## ADDENDUM NUMBER 2

**H27-6096-MJ**

**Outdoor Football Practice Felds Construction  
University of South Carolina**

LD DETAILS  
TERNATE #1  
02 OF 7  
T IN SET:  
N/A

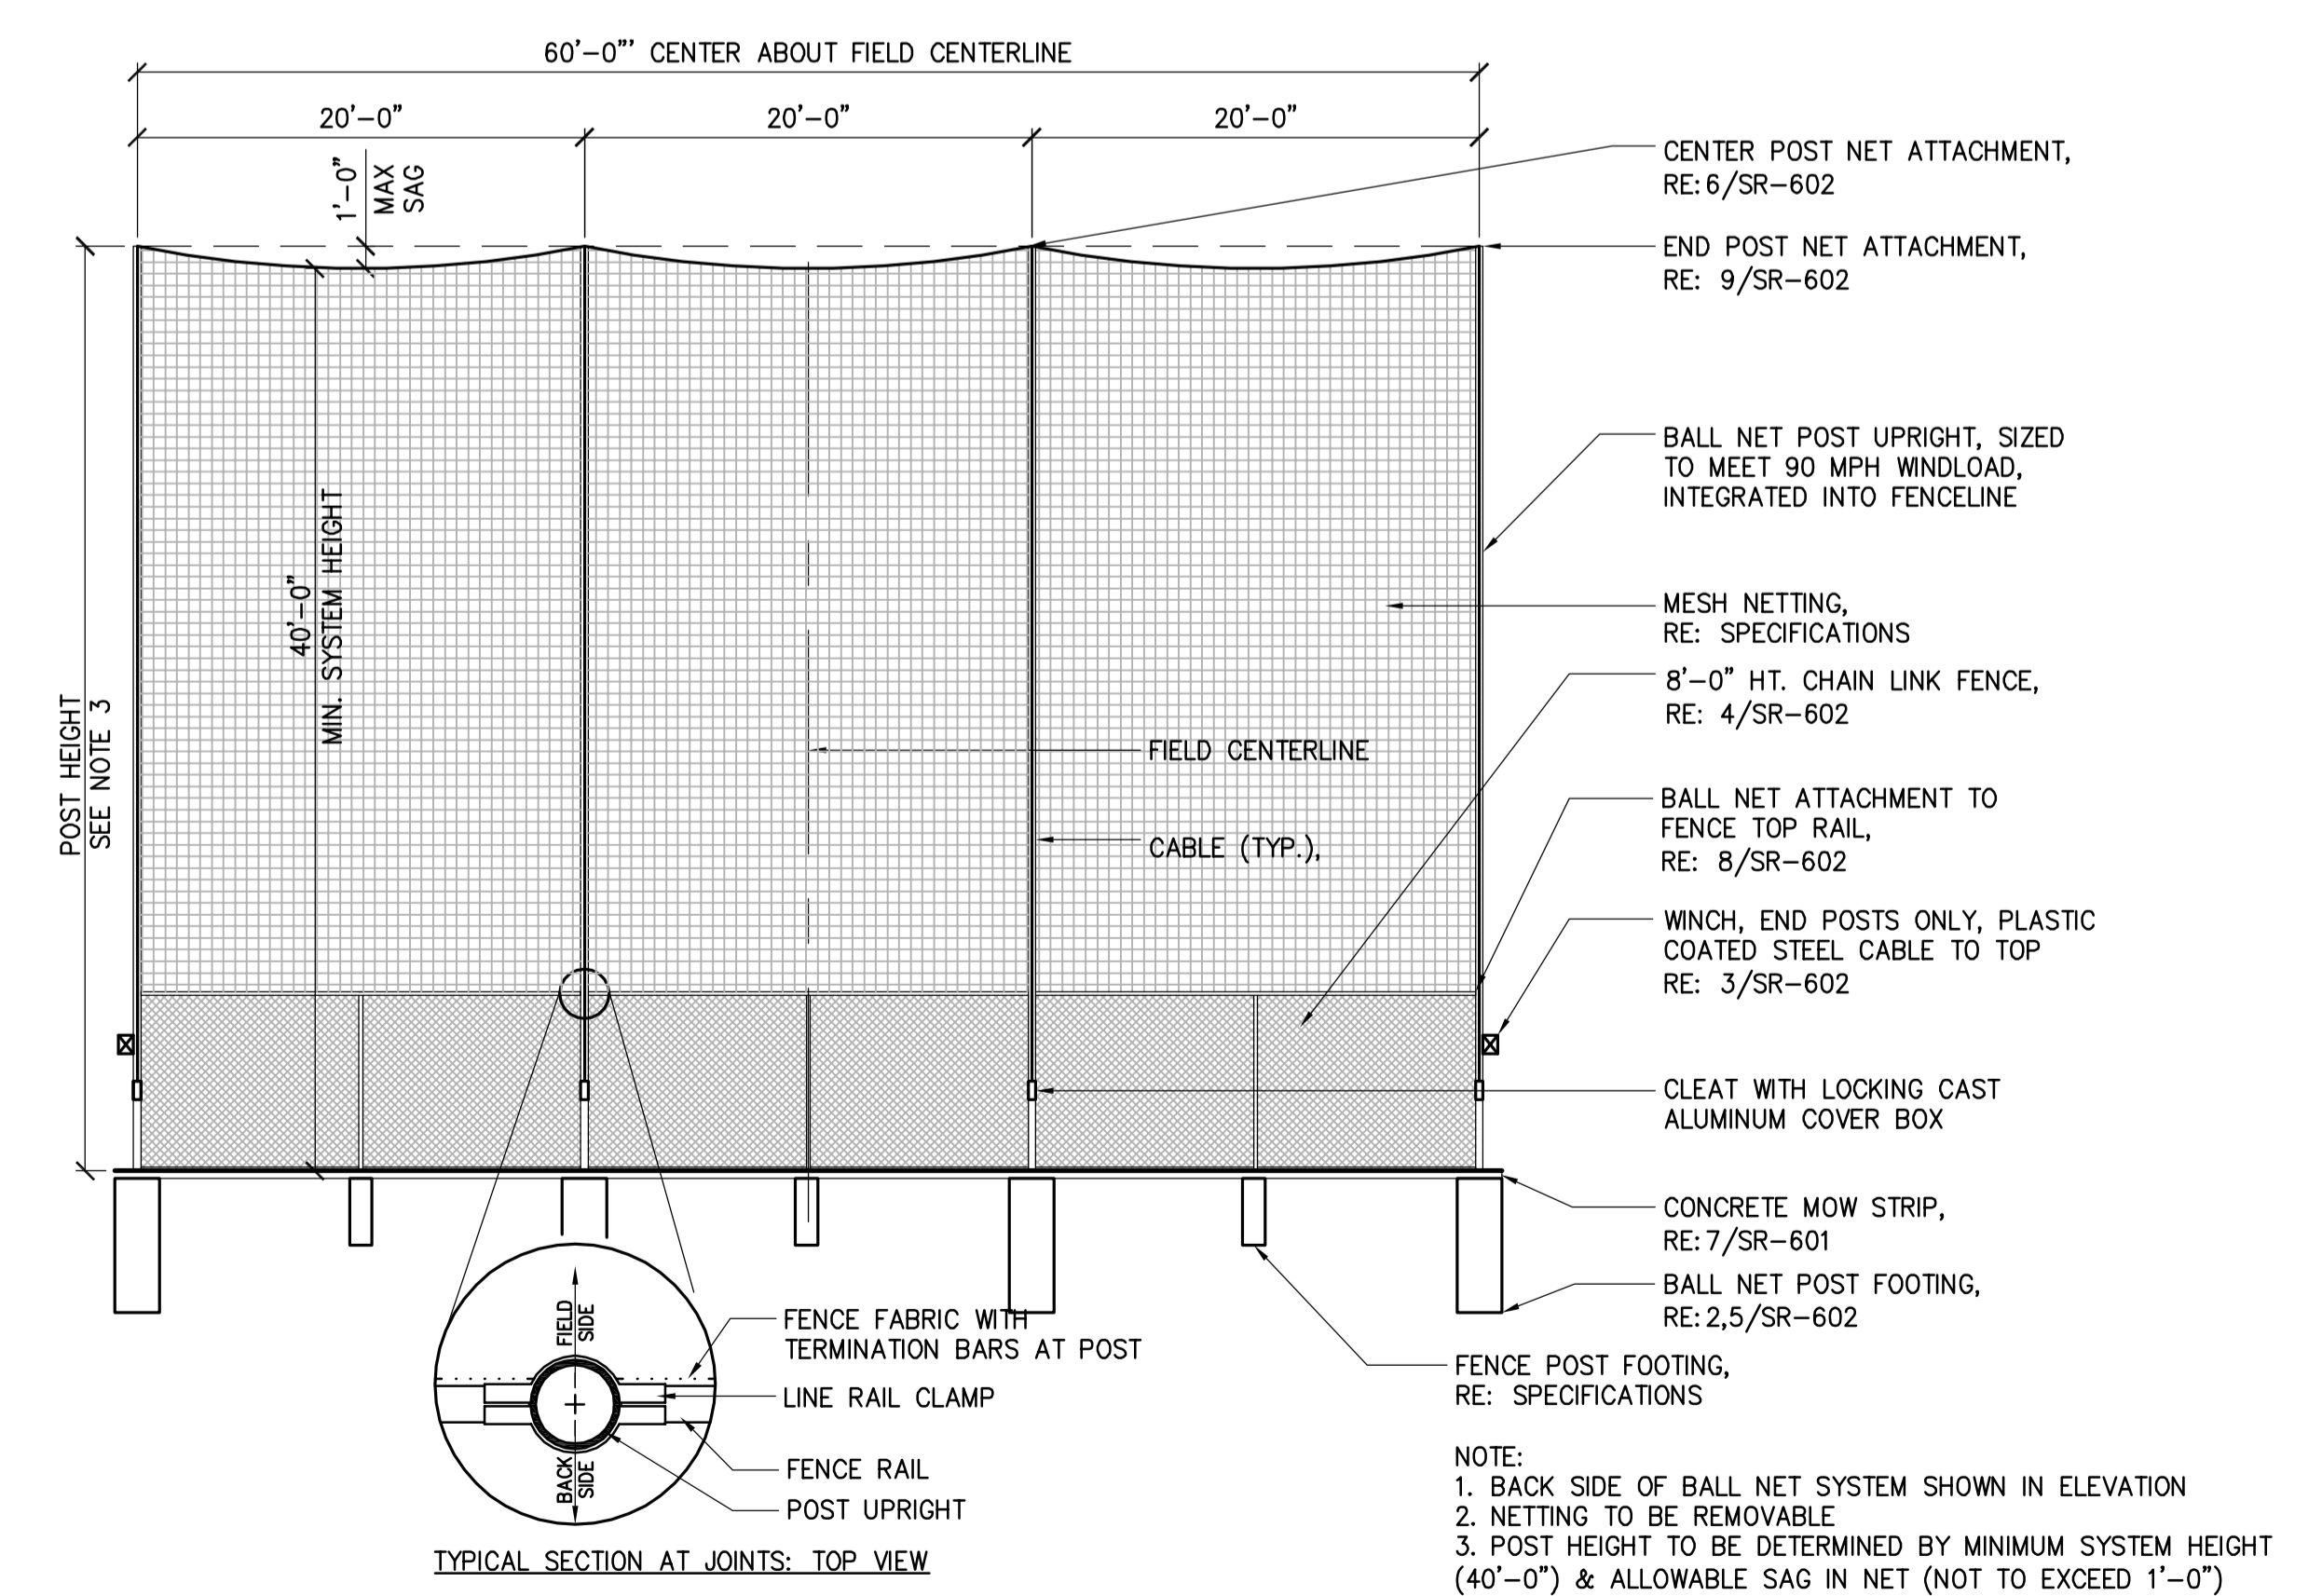
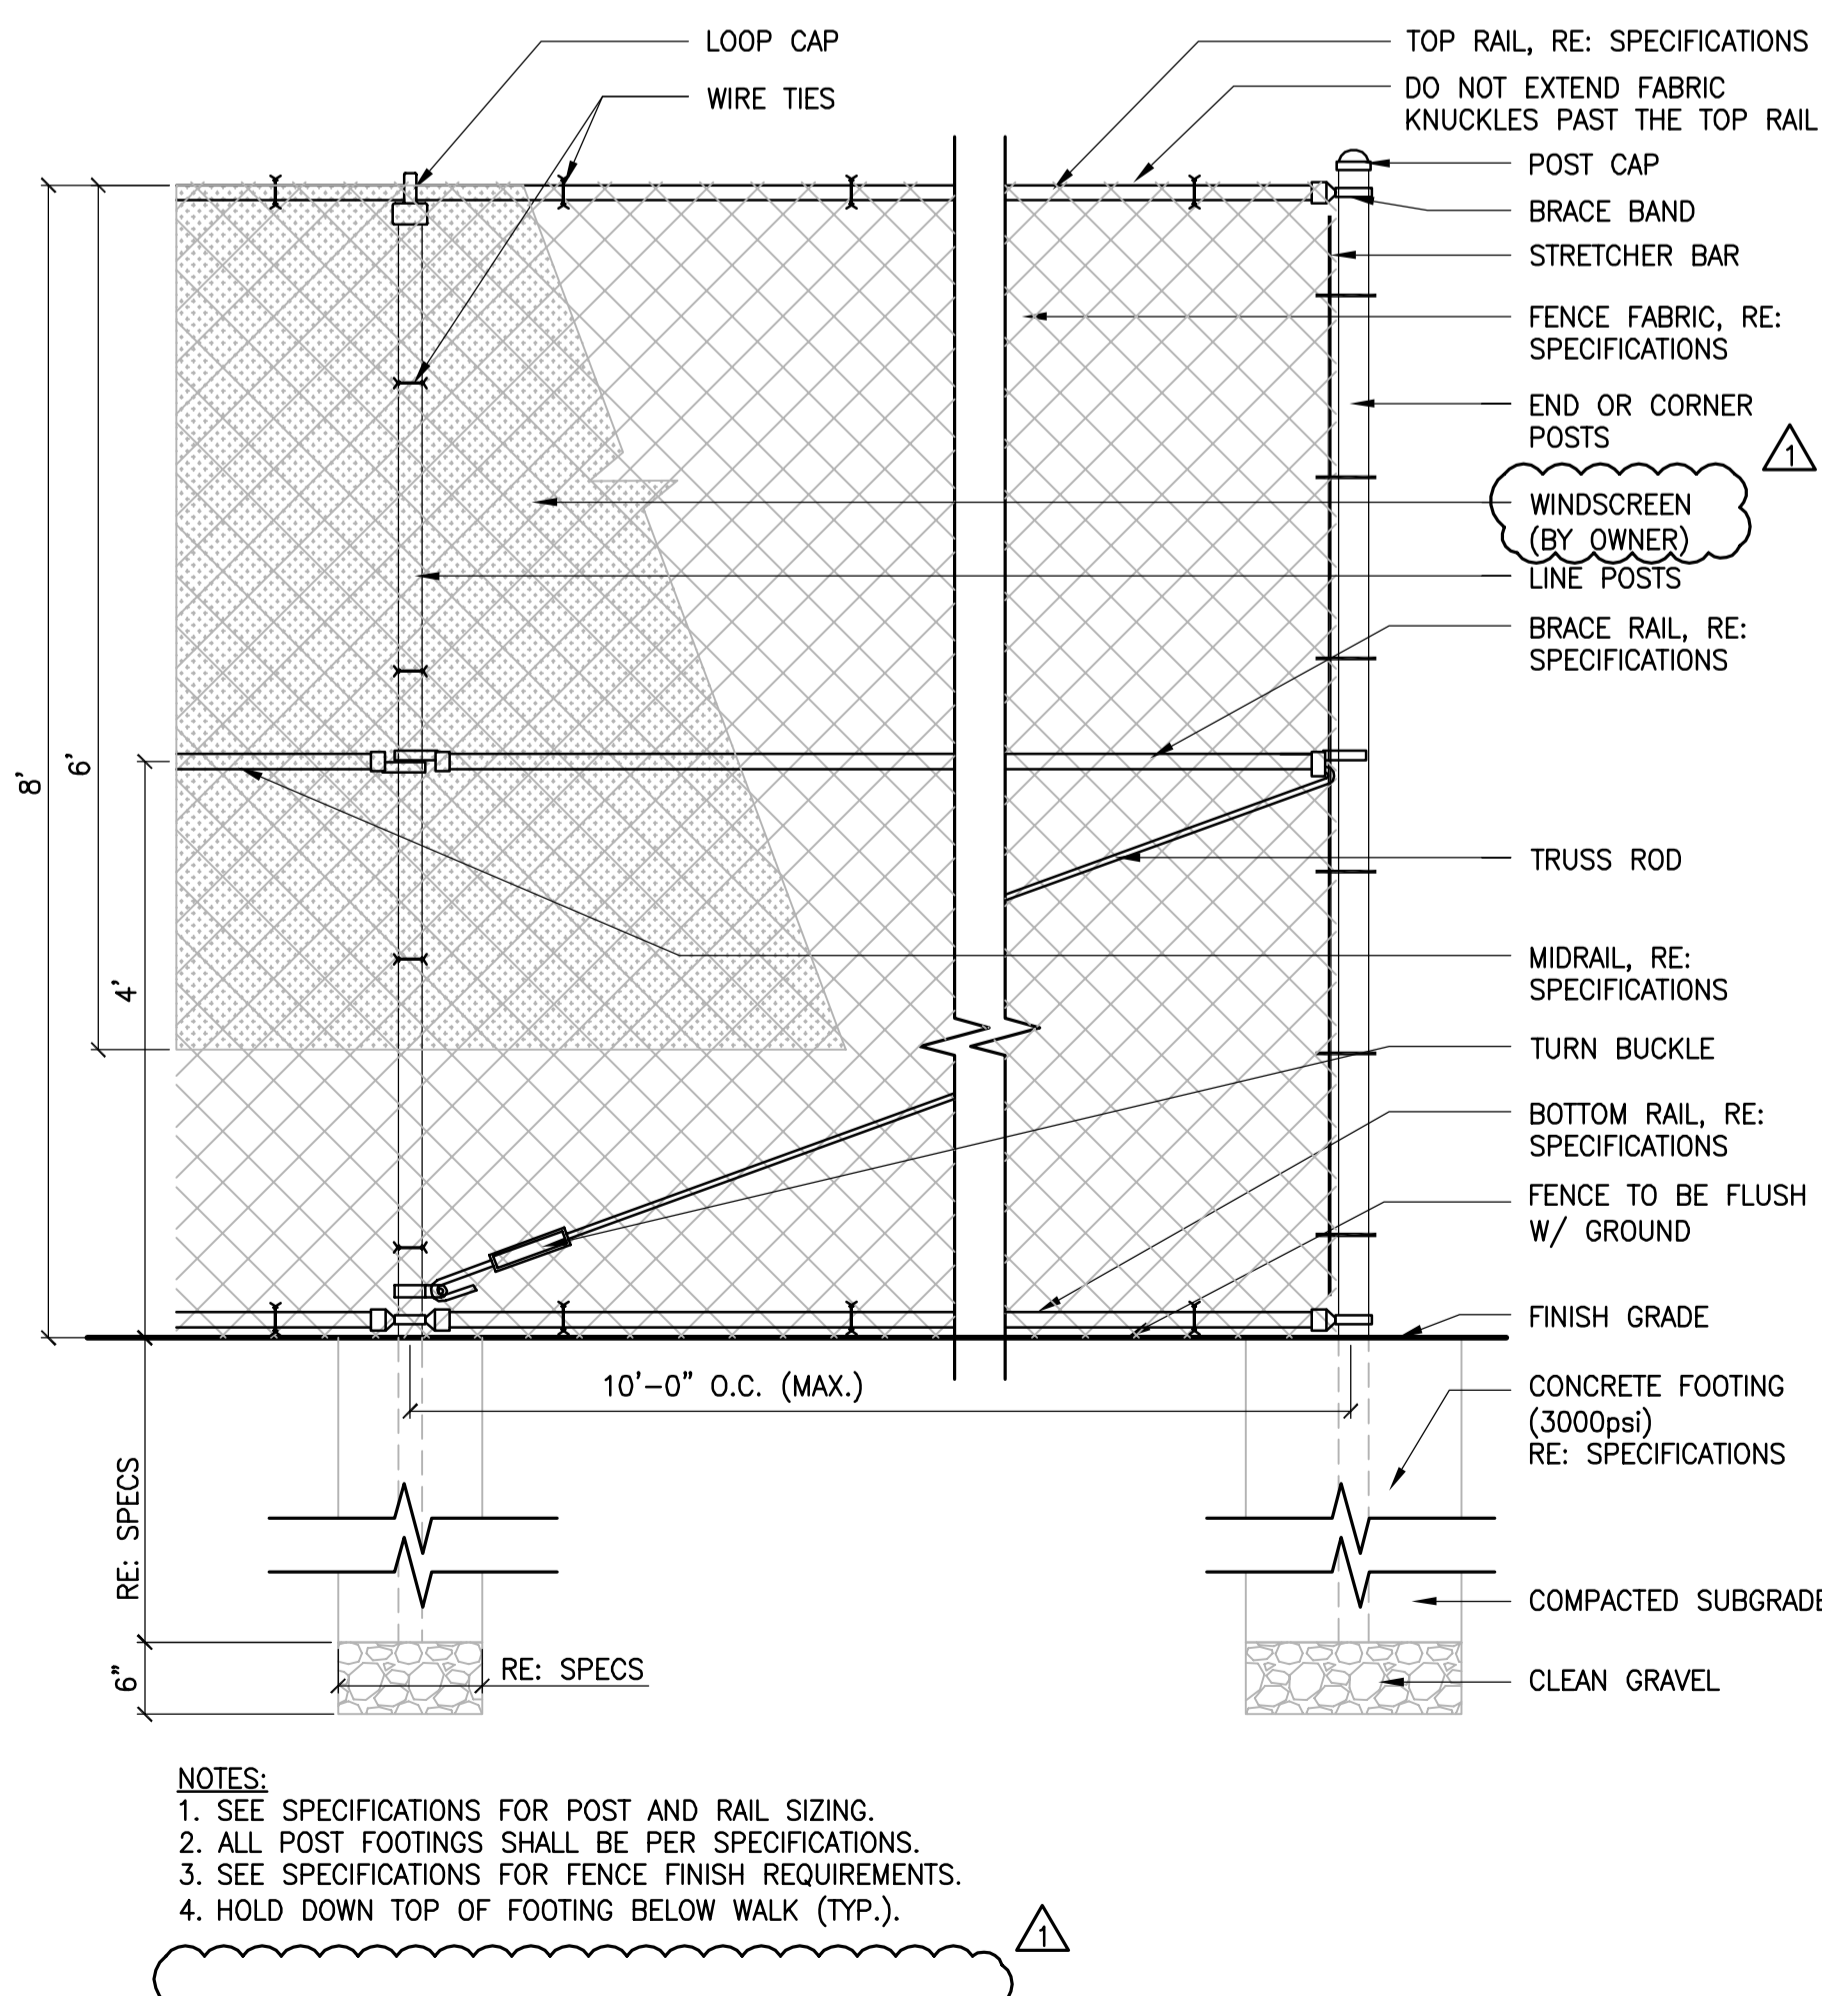
- a. Sheet SR101 - Reissued to reflect filming tower alternate #2
- b. Sheet SR601 - Reissued to include specification for elastic Curb
- c. Sheet SR602 - Reissued to reflect the wind screen provided and installed by the Owner.
- d. Sheet A 1.1 - Reissued to show filming tower base bid and alternate #2 scope of work.
